**FILE NUMBER:** PLN22-234  
**SUBJECT:** Special Permit and Design Review Application for Small Scale Permanent Agricultural Employee Housing  
**SITE LOCATION:** 2425 Old Calaveras Road, Milpitas 95035 (APN: 029-34-004)  
**DATE RECEIVED:** December 27, 2022

**PLANNING OFFICE**

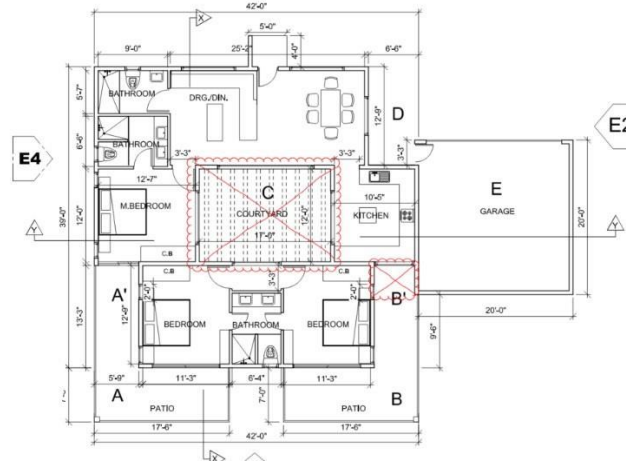
4. The submitted site plan does not provide information about the height of fences. Please identify the height of the existing/proposed fences on your site plan.

Response: The site plan shows the height of the existing fences that will remain in two areas.

1. The existing fence that will remain at the height of 5’ 2” behind the small scale agricultural permanent employee house is shown in sheet C2.1
2. The existing fence that will remain at the height of 6’ near the property entrance at Old Calaveras Road is shown in sheet C1.1

There are no new fences proposed in this application. This note is added in the sheet C1.1.
